Noise Feasibility Study

Proposed Seniors Residential Development

7211 and 7233 Airport Road

Appendix A – Comments from City and HGC Engineering’s Responses

Figure 2: Proposed Site Plan

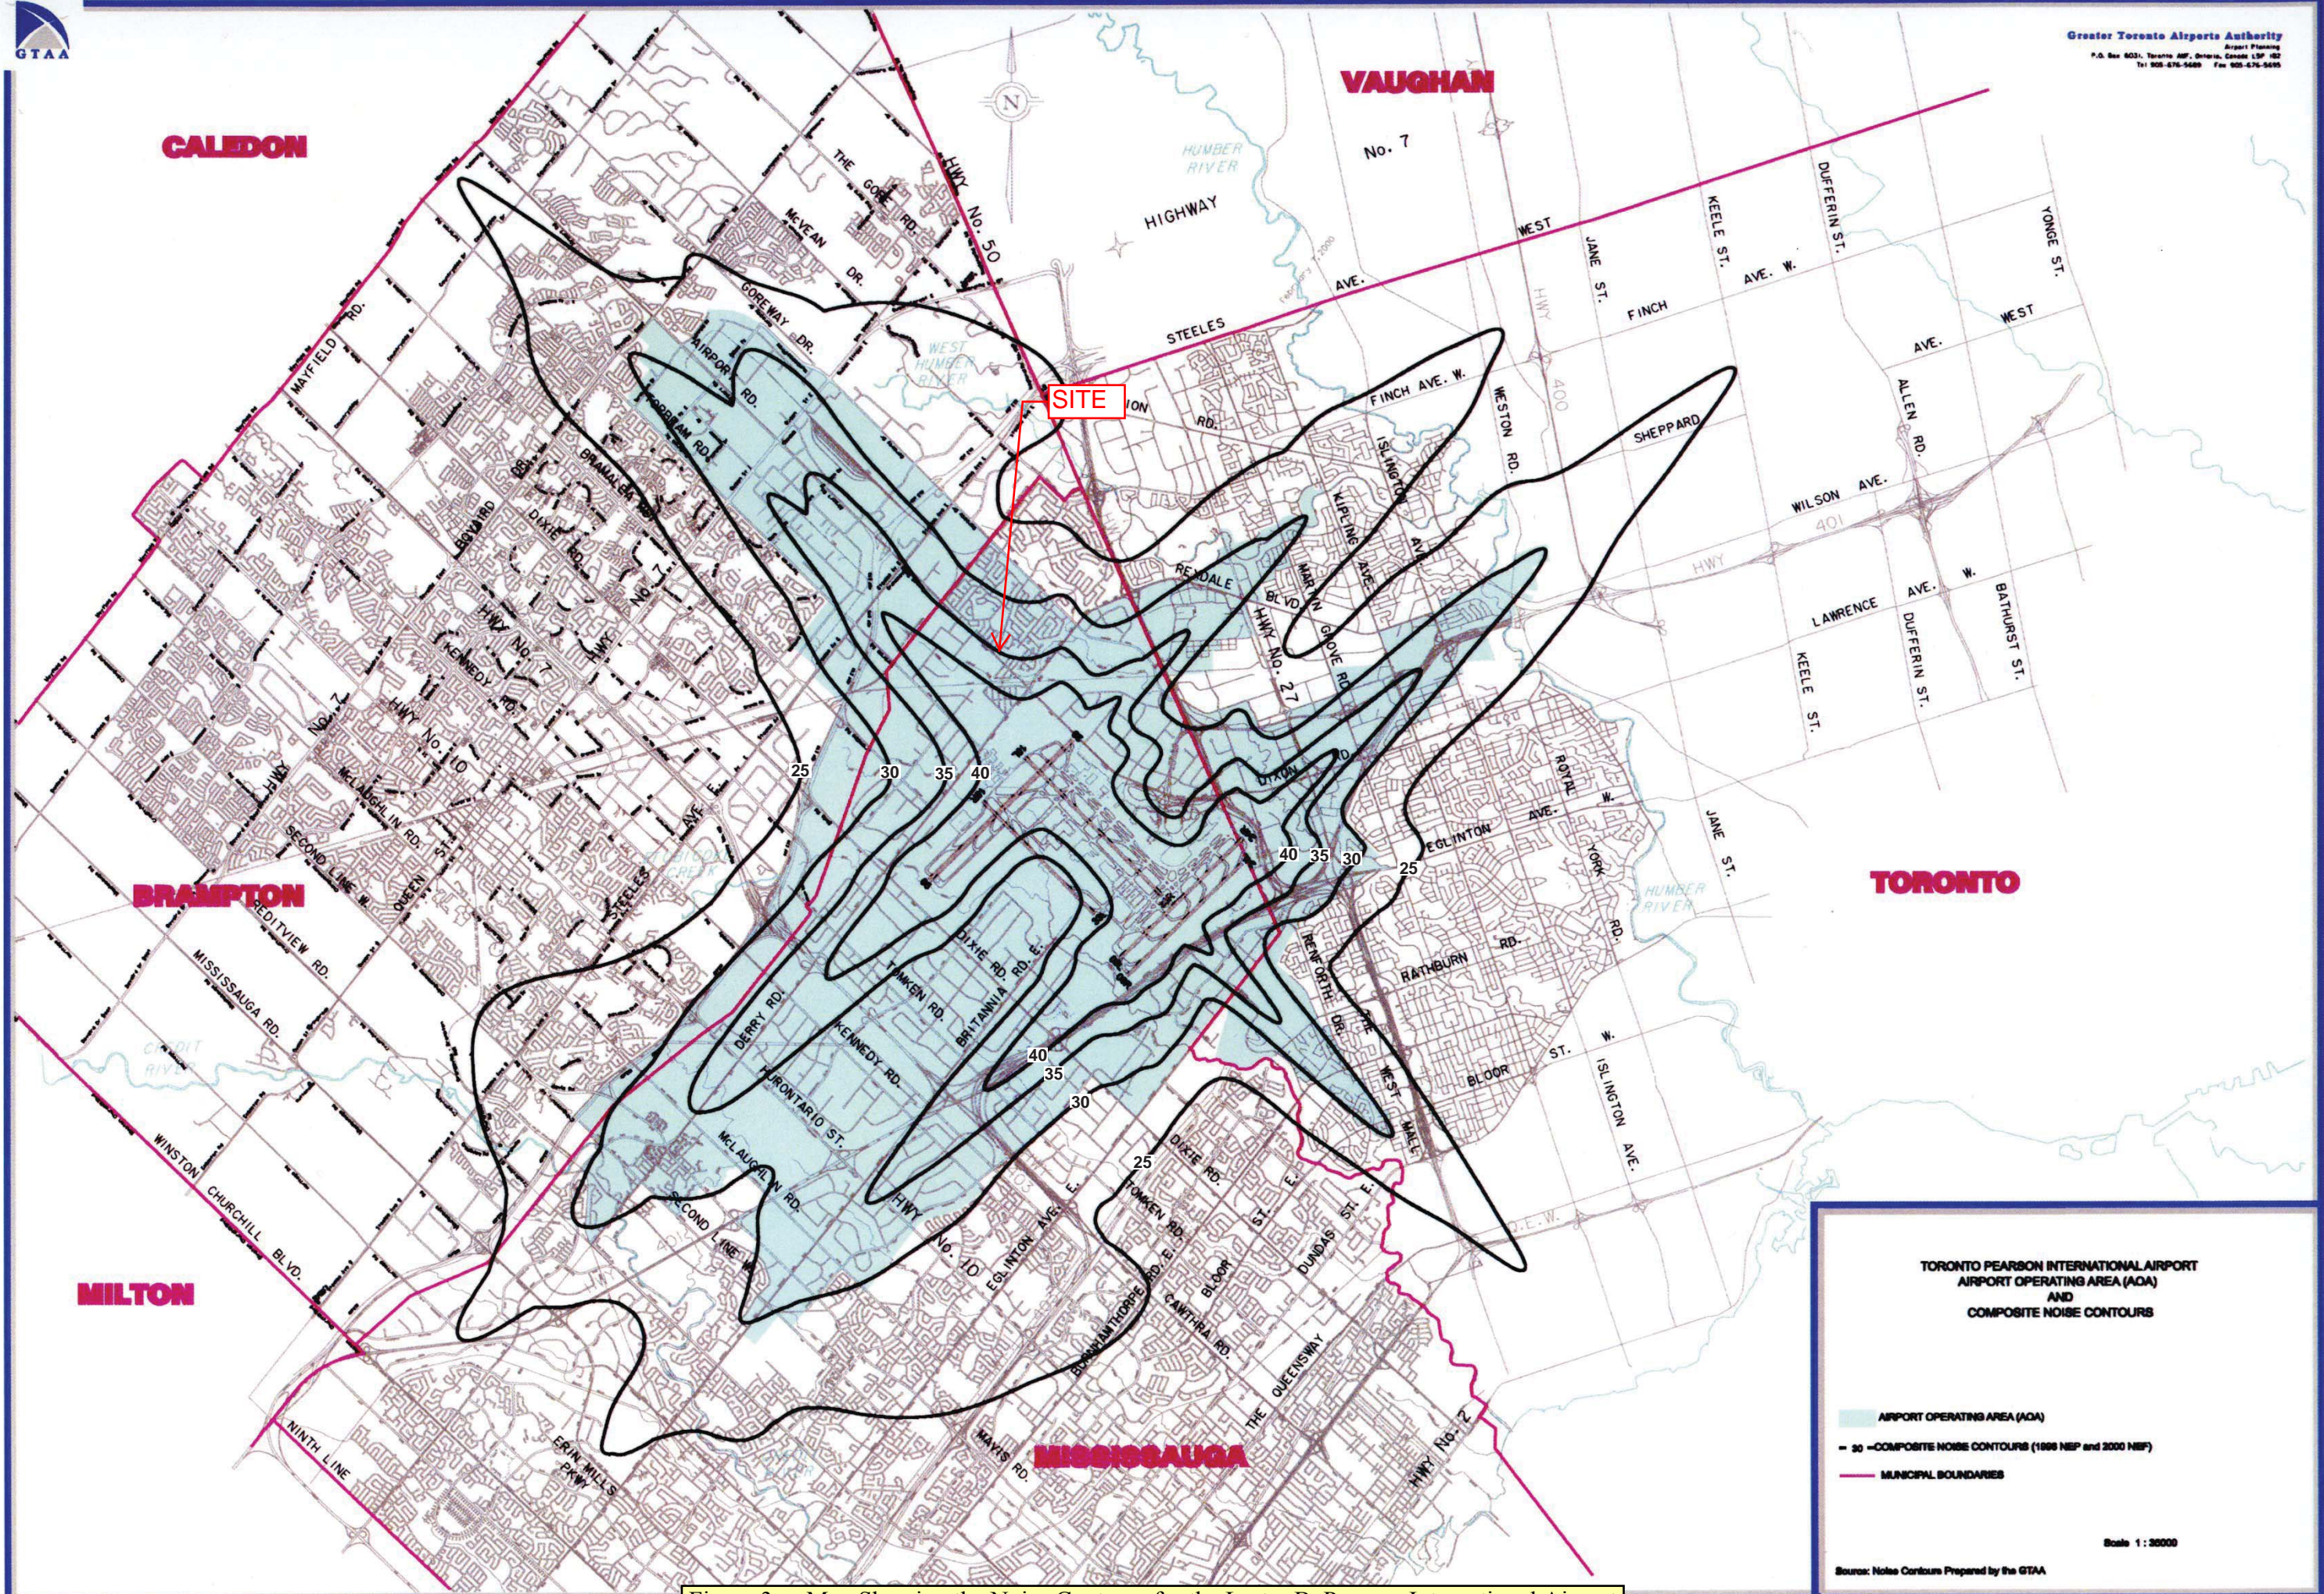
<p>assessment points in Figure 2 appear to be duplicated for points B,E and F. Please clarify; or identify the actual locations at which noise levels were assessed and label accordingly. PREVIOUS COMMENT: A letter from HGC Engineering dated January 28, 2020 was received, however none of the original Noise Study (dated Dec 15, 2017) comments were addressed. Please provide an updated Noise Study with the next circulation. Further comments may be pending upon review of the updated report. The owner is to submit an updated Noise Study which is to include the following: (i) Show all STAMSON outputs in the Appendix. (ii) Assess the noise levels for all the amenity areas as per the latest site design. Include a table showing the unmitigated noise levels for all OLAs. (iii) Include a table showing mitigated sounds levels from 55 to 60dBA versus barrier heights for road traffic noise. (iv) As this development is located within the NEF/NEP 36 aircraft noise contour, the owner will be required to enter into an agreement with the City and GTAA. See comment #8 for further details. (v) Include a plan in the Appendix showing the location of all noise assessment points. (vi) The report states under section 2 that apart from road and air traffic, there are no other major sources of significant noise evident within 500 metres of the site. However, a warning clause is recommended for commercial facilities under Section 5.4. Please clarify. (vii) Confirm that the Ultimate Traffic data for Airport Road is still valid, given that the data provided in the Appendix is from 2014. (viii) The report is to include a description of impacts of noise generated by a proposed development on the surrounding environment, as well as the impact of noise from the proposed development on itself.</p>	<p>comment was <i>Include a plan in the Appendix showing the location of all noise assessment points.</i></p> <p>This was completed.</p>

(v) Yes that is correct. The points are duplicated since they have the same exposure of sound from road/air traffic. The locations B, E and F are at the same floor but on the north and south of the building. The previous
